WEST SUSSEX COUNTY COUNCIL CONSULTATION

TO:	Arun District Council FAO: Hannah Kersley
FROM:	WSSC – Highway Authority
DATE:	6 October 2026
LOCATION:	Phase 6a Hampton Park Littlehampton
SUBJECT:	LU/249/25/RES Approval of reserved matters following LU/47/11/ (amended by LU/182/15) comprising 288 No residential dwellings, the formation SUDs features, children's play space, landscaping, car parking, roads, landscaping and public access to the northern extent of the Black Ditch Open Space. Substitute drawing pack plans and additional plans received.
DATE OF SITE VISIT:	n/a (desktop study undertaken as site visited previously)
RECOMMENDATION:	More Information Required

This is the **second** WSSC Highways response to the above planning application seeking approval of reserved matters following LU/47/11/ (amended by LU/182/15) comprising 288 No residential dwellings, the formation SUDs features, children's play space, landscaping, car parking, roads, landscaping and public access to the northern extent of the Black Ditch Open Space.

Figure 1 – Screenshot of sheet 3: Annotated to show hedgerows within areas likely to be offered for highway adoption and containing hedgerow planting (note the northern hedgerow is within the assumed indicative visibility splay shown). Hedgerow to be removed from the plans.

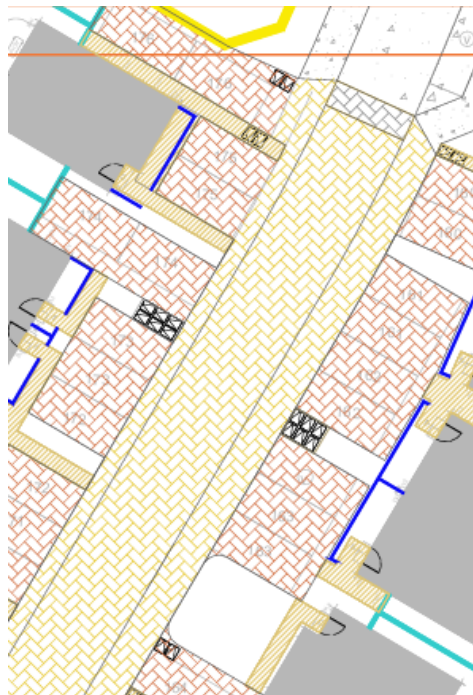
- All tree planting should be set back by at least 1m from the edges of any hard surfacing proposed for highway adoption.
- Tree selection: *Malus* 'John Downie' should be avoided near to footways of carriageways which are to be proposed for highway adoption due to fruiting abundance and relating future nuisance concerns.
- Hedgerow planting will not be acceptable for highway adoption due to ongoing maintenance requirements (sheet 3, x2 locations).
- Planting should not obstruct forward visibility of junctions (sheet 3, x1 hedgerow).

- Planting should not obstruct forward visibility of junctions (sheet 3, x1 hedgerow). **Hedgerow is still shown in the northern-most red-edged location shown below. This should be removed.**

- Figure 1 – Screenshot of sheet 3: Annotated to show hedgerows within areas likely to be offered for highway adoption and containing hedgerow planting (note the northern hedgerow is within the assumed indicative visibility splay shown). Hedgerow to be removed from the plans. **Hedgerow is still shown in the northern-most red-edged location shown below. This should be removed. For the southern-most red edged location, the hedge should be squared-off to ensure that visibility for users of the parking bay and for pedestrians crossing at this point is maximised. Please see extract above circled in blue (applicable to the southern hedgerow).**
